Appendix 5.

Schematics

WU5108 1T1R 802.11b/g/n USB WLAN

AboCom Systems, Inc			
Title: WU5108 802.11b/g/n USB WLAN			
Size: B	Document Number: 1.Cover	Rev: D10	
Date: Monday, April 18, 2011	Sheet: 1	of: 4

AboCom Systems, Inc		
Title WU5108 802.11b/g/n USB WLAN		
Size B	Document Number 4.RF	Rev D10
Date: Monday, April 18, 2011 Sheet 4 of 4

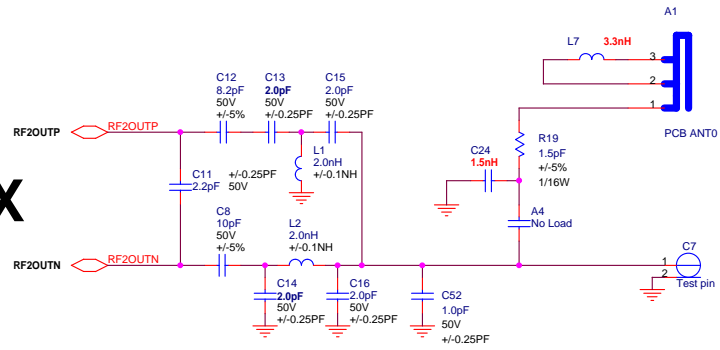
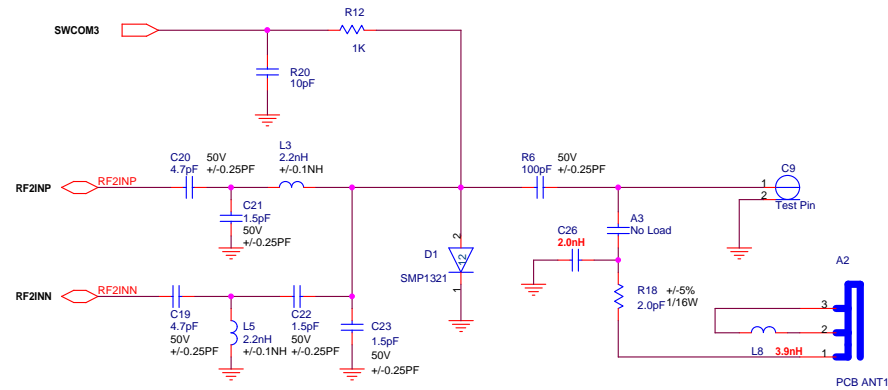
DATE	REVISION NUMBER	INITIALS	DESCRIPTION
2010/06/13	WU5108-X1	CASH	Initial release.
2010/06/28	WU5108-X2	CASH	For Antenna match (TOKO Only) L7 4.3nH change to 3.3nH C24 2.0nH change to 1.5nH L8 4.3nH change to 3.9nH
2010/06/28	WU5108-D1	CASH	For TX/RX EVM C8 8.2pF change to 10pF C12 8.2pF change to 10pF L1 2.0nH change to 1.8nH L2 2.0nH change to 1.8nH For RX Sensitivity C19 4.7pF change to 10pF C20 4.7pF change to 10pF C23 1.5pF change to 1.0pF
